Project Name: Pinehaven Stream Improvements
Project Number: IZ089000

Subject: Response to section 92 requests for further information

Subject: Response to section 92 requests for further information

TITLE DESIGNATION PLAN SHEET 4		REV B
SCALE 1:500 @ A3	DRAWING No. I2089000-SP0-400-GN-DRG-0104

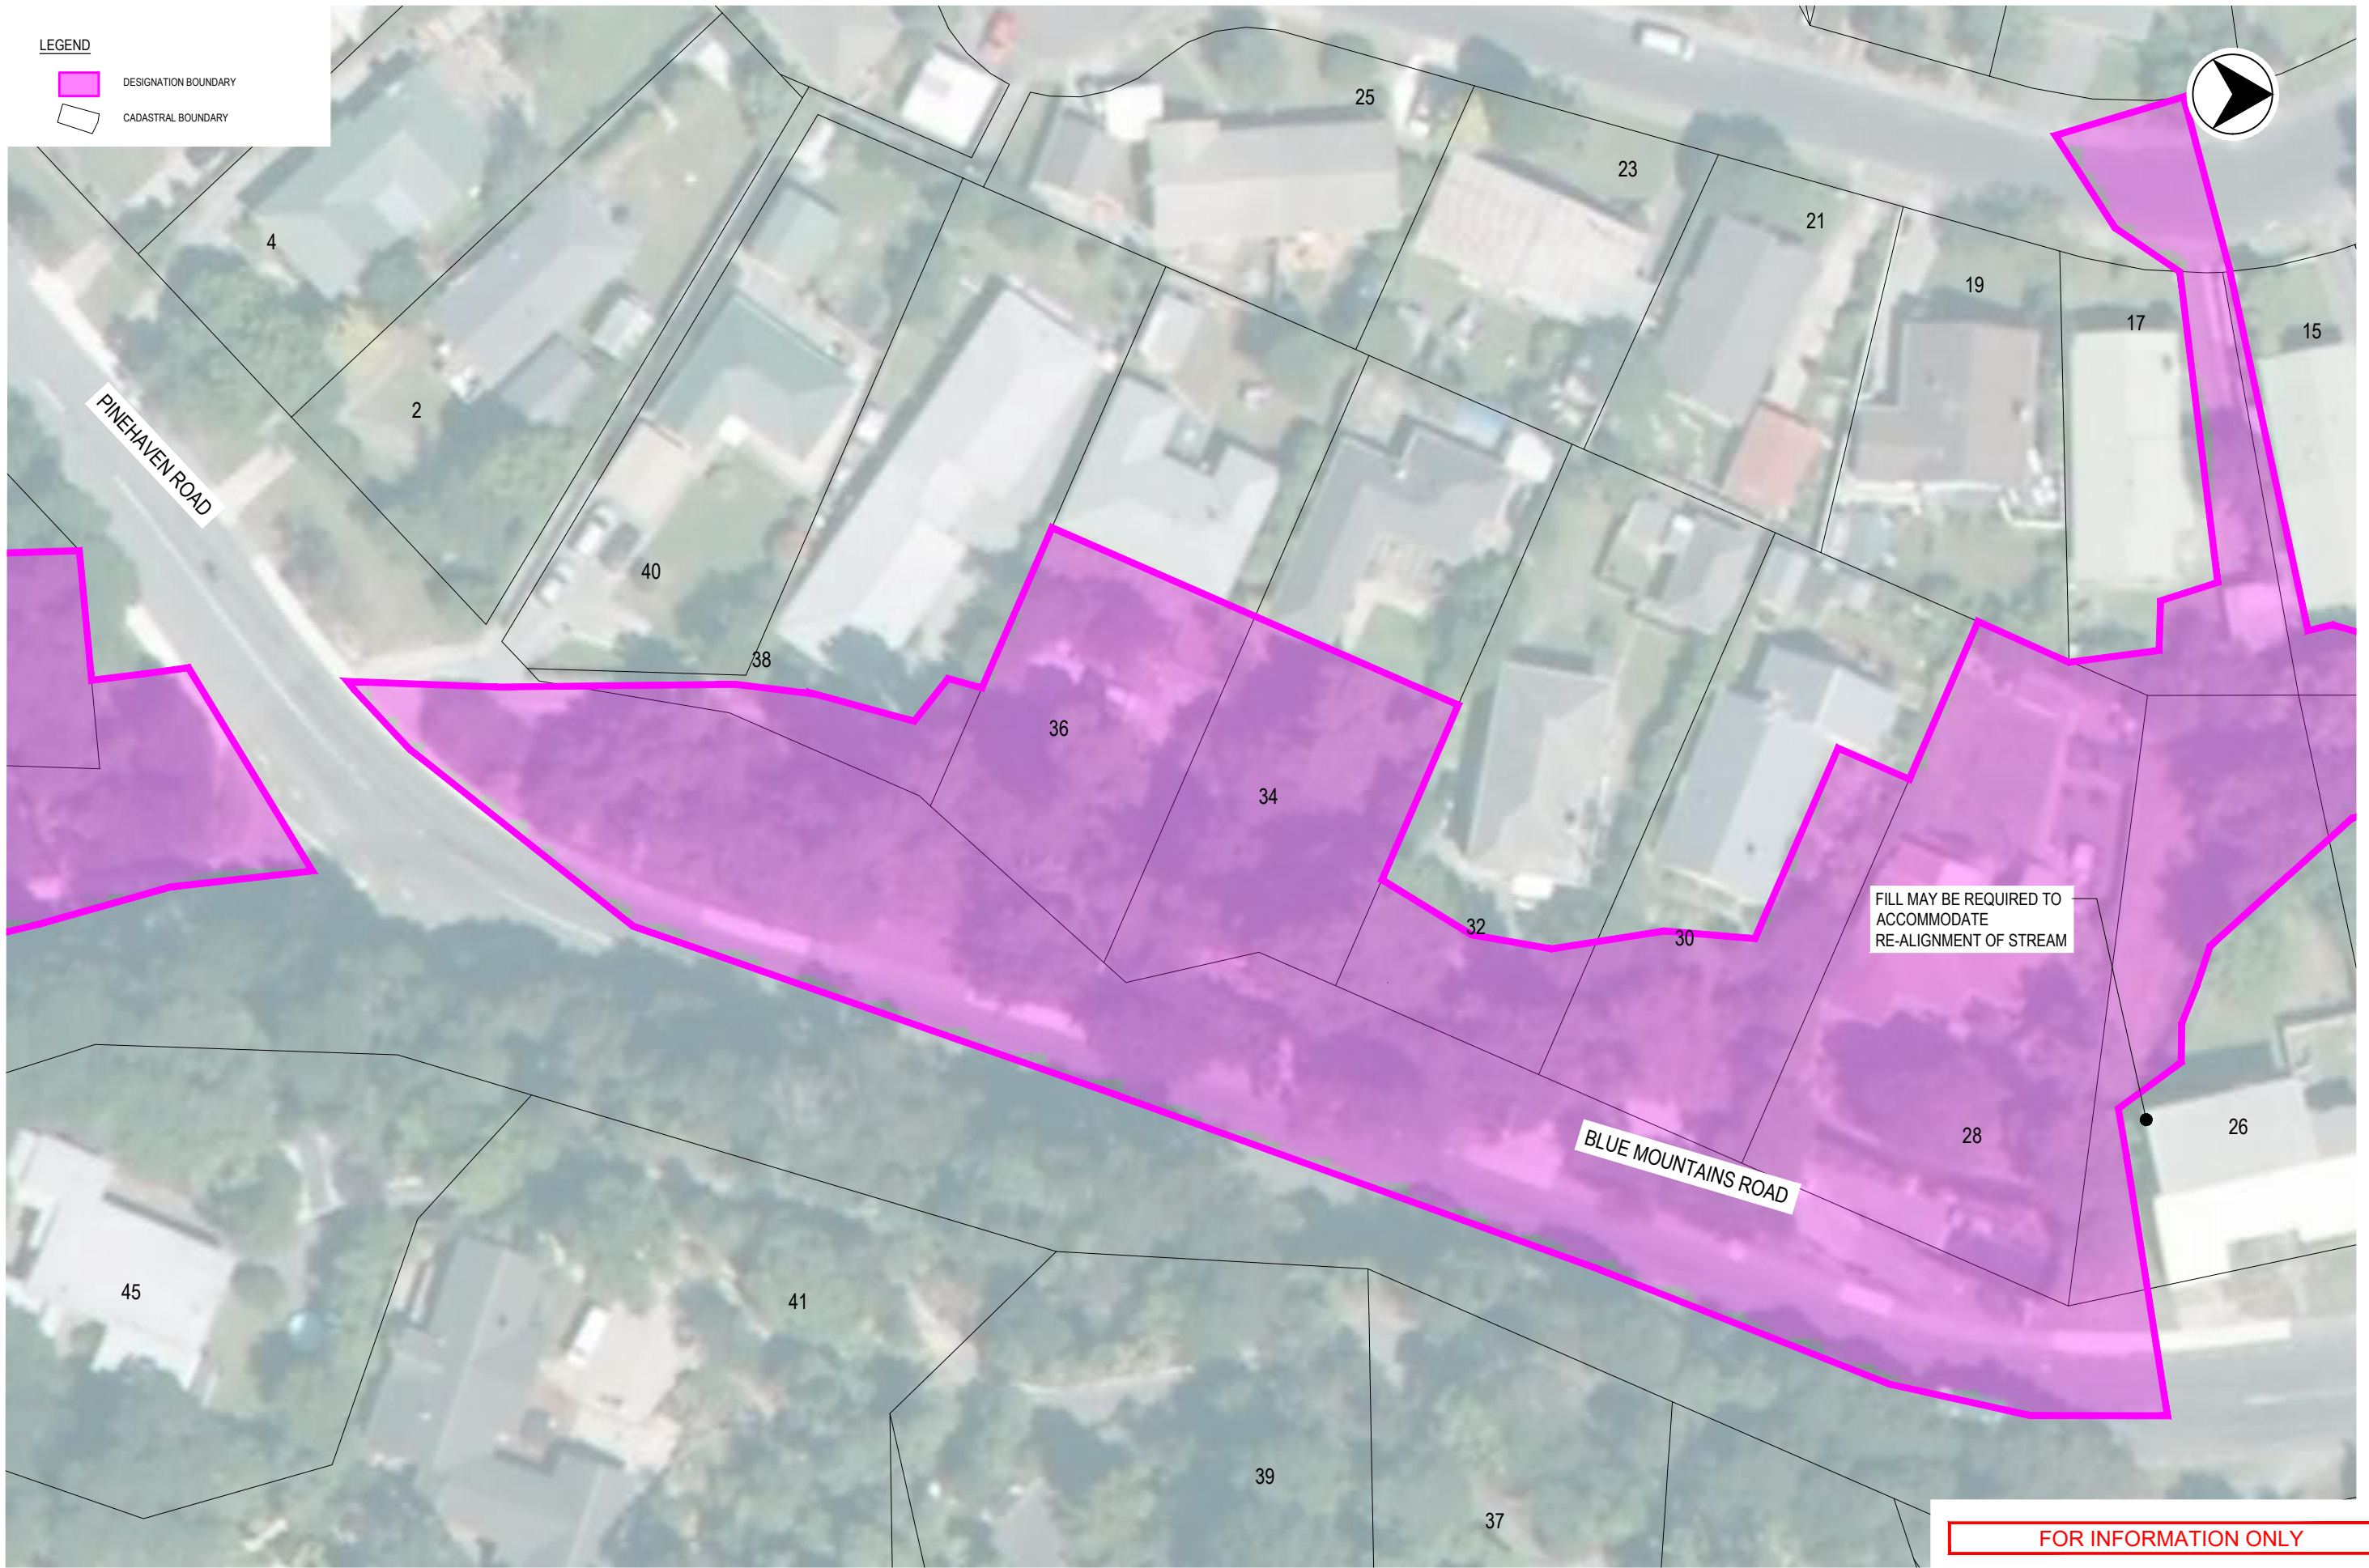
6.	<p><i>The Council District Plan has minimum access width requirements for private ways and rights of ways. As details have not been provided on the proposed bridges that provide access to multiple properties, it is difficult to confirm if the proposal meets these requirements. Are there any initial bridge designs available that can be reviewed to confirm if these width standards will be met?</i></p>	<p>The proposed bridges for the private driveway access will be approximately 3.7 metres wide. This is shown on the concept plans attached at Appendix E.</p> <p>The proposed shared access will comply with the requirements of Standard 18.9 - Access standards for subdivision and land use activities. No minimum access width requirements are identified within the Upper Hutt City Council District Plan. The widths stated in Appendix C, Figure 1 of the Code of Practice for Civil Engineering Works relate to road design, rather than private driveway widths. In addition, as stated on the Upper Hutt City Council website, Part C of the CoP forms a means of compliance but remains outside the District Plan.</p> <p>The bridges and accesses will be designed in accordance with the following:</p> <ul style="list-style-type: none"> · UHCC Code of Practice for Civil Engineering Works; and · NZTA Bridge Manual, 3rd Edition <p>Section B1.10.2 of the Code of Practice for Civil Engineering Works states that the minimum width for accessway to Services for Vehicles should be 'adequate for their purpose but in no case less than 3 metres in width.' In neighbouring Hutt City, the standard and minimum width of a residential driveway crossing is 2.5 metres. For the private driveway access bridges, the proposed design width of 3.7 metres is proposed, which is greater than both of these standards.</p>

Please also note that a change to the designation footprint within 30 Blue Mountains Road is proposed to provide for the driveway. Please refer to amended Sheet 3 of the General Arrangement plans and Sheet 4 of the designation plans attached at Appendix D.

Appendix E. Private vehicle shared accessway bridge concept design

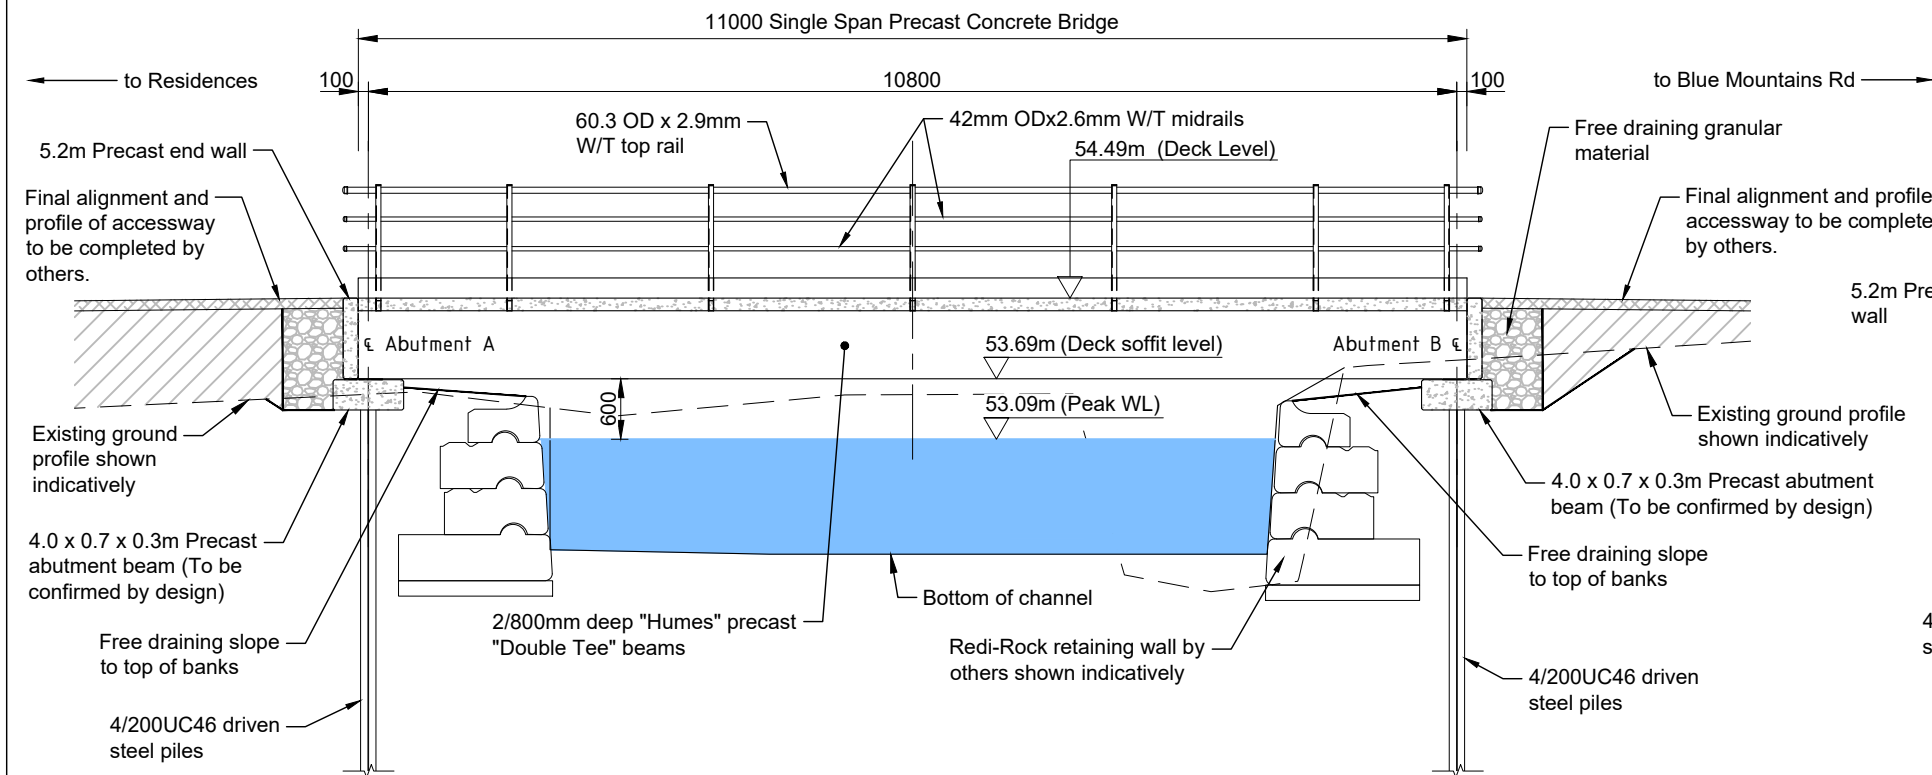
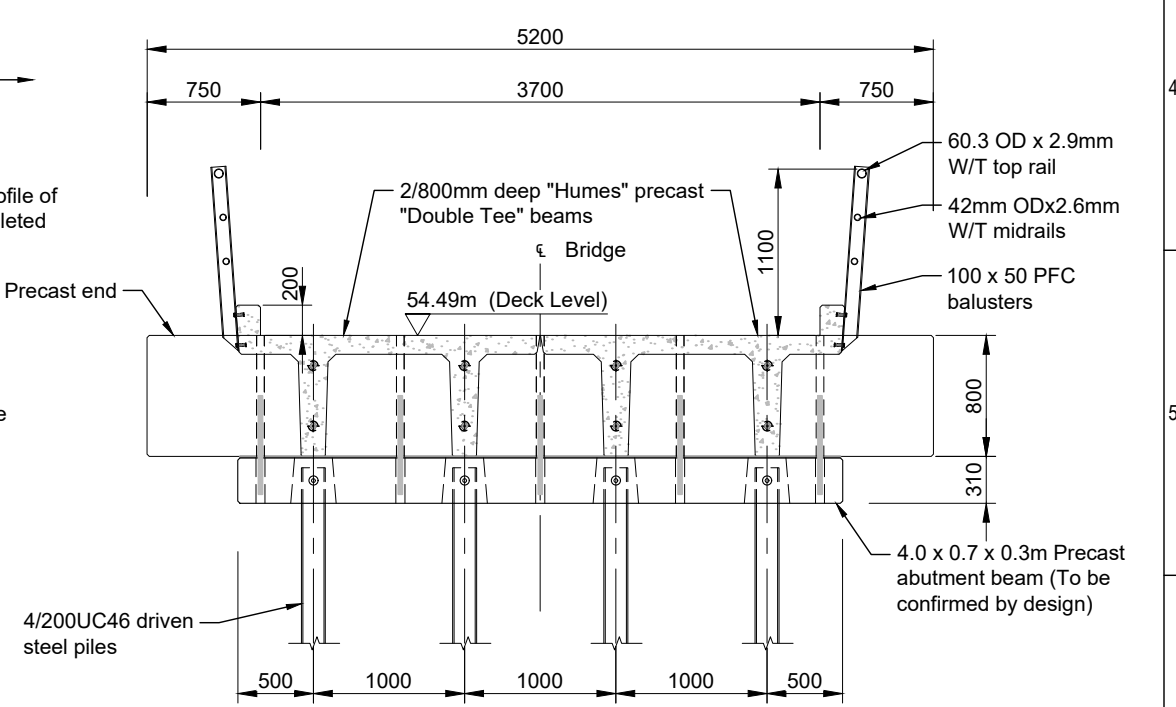
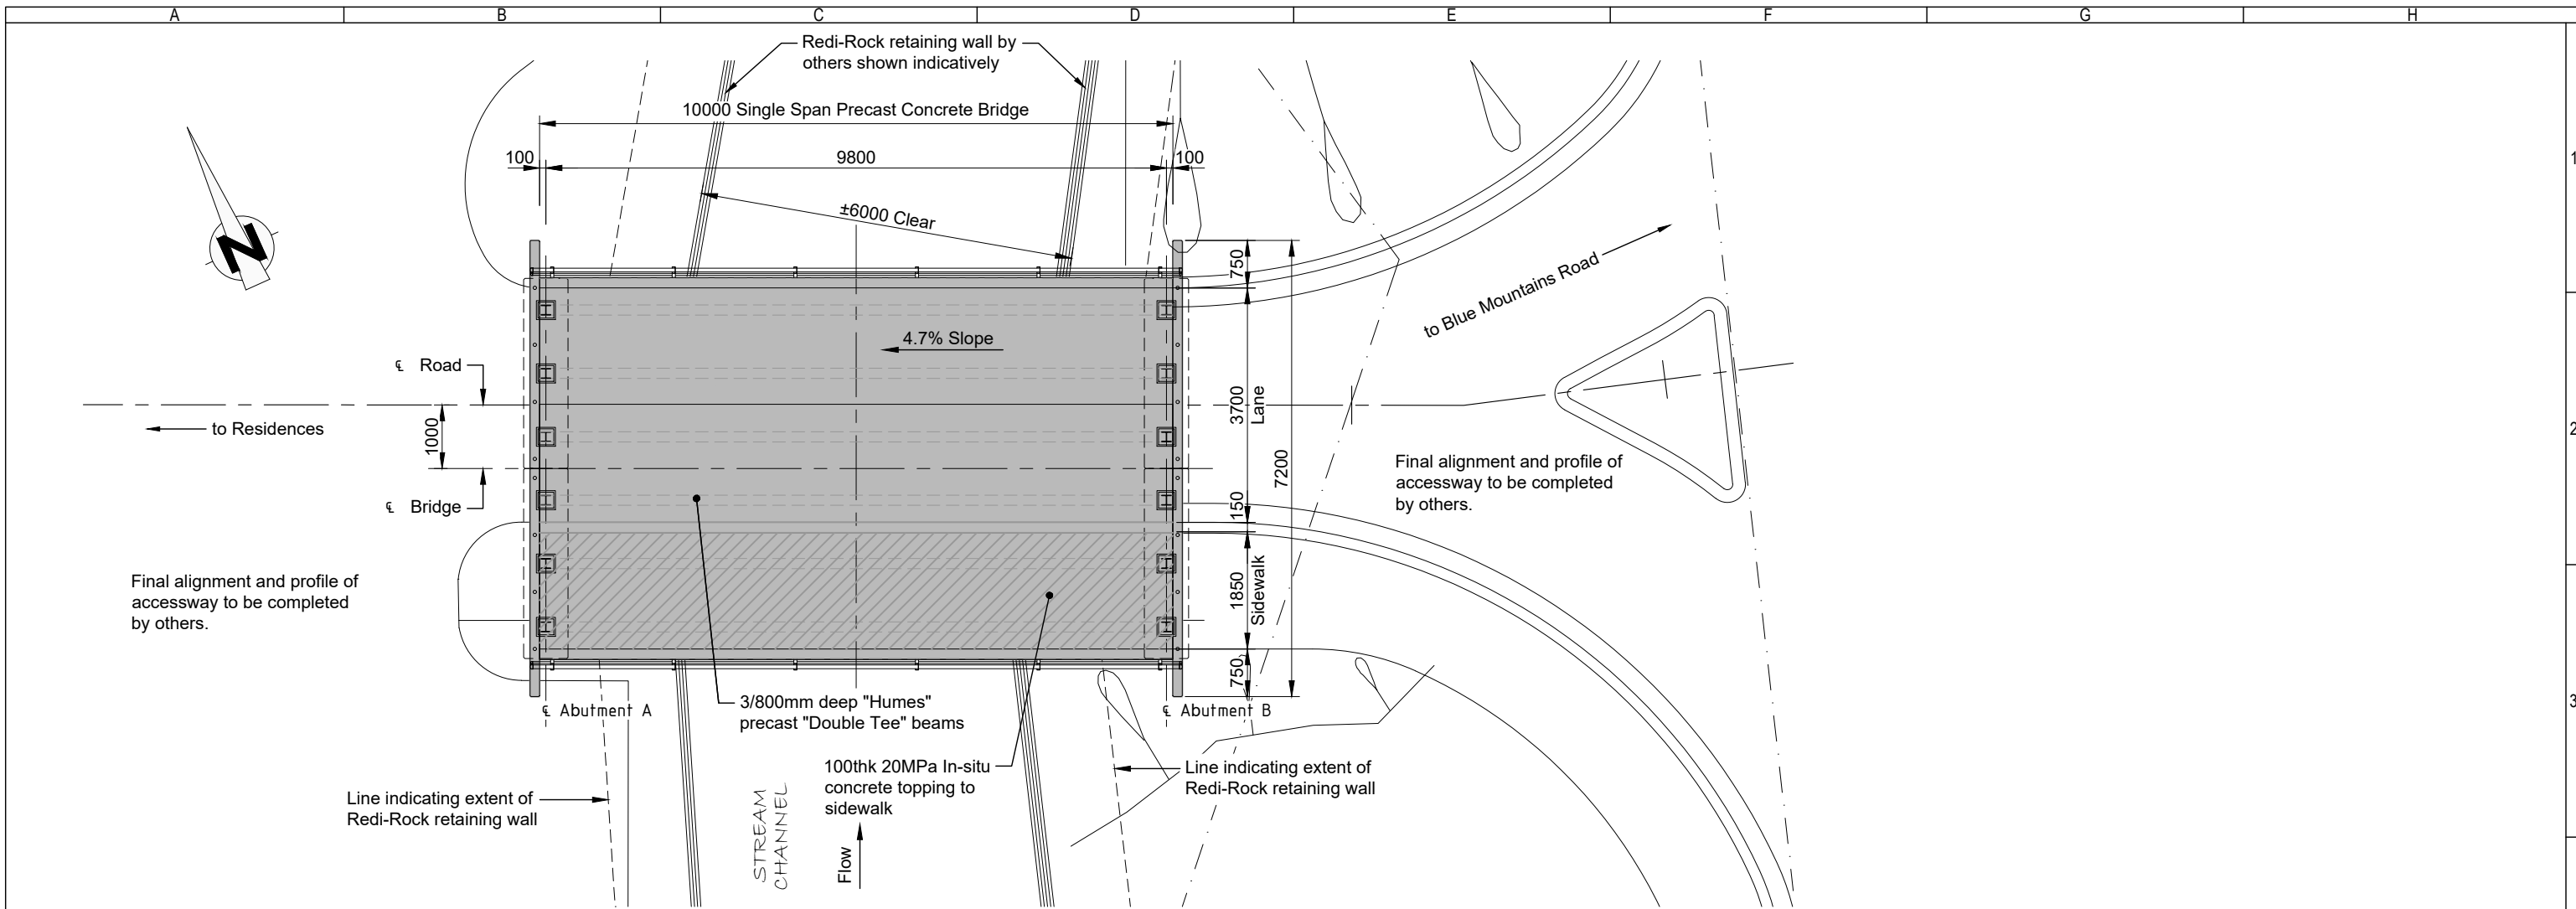
5.	<p><i>Many of the new bridges will provide access to multiple properties. Can you please confirm how legal access will be provided to the residential properties having access over these bridges and when this legal access will be established?</i></p>	<p>Access to the properties impacted by the works is currently being negotiated with the various owners. All owners have been presented an agreement to provide access to construct the works under section 181 of the Local Government Act 2002. As at the date of this response, only one landowner is yet to sign the necessary agreements, with the expectation that this will be provided prior to commencement of construction. The legal arrangements for new accessways that are required to be created is still being discussed with Upper Hutt City Council and the landowners. It is likely Upper Hutt City Council will retain responsibility for the maintenance and upkeep of the access bridges.</p> <p>Legal access arrangements will be confirmed prior to bridge construction commencing.</p>
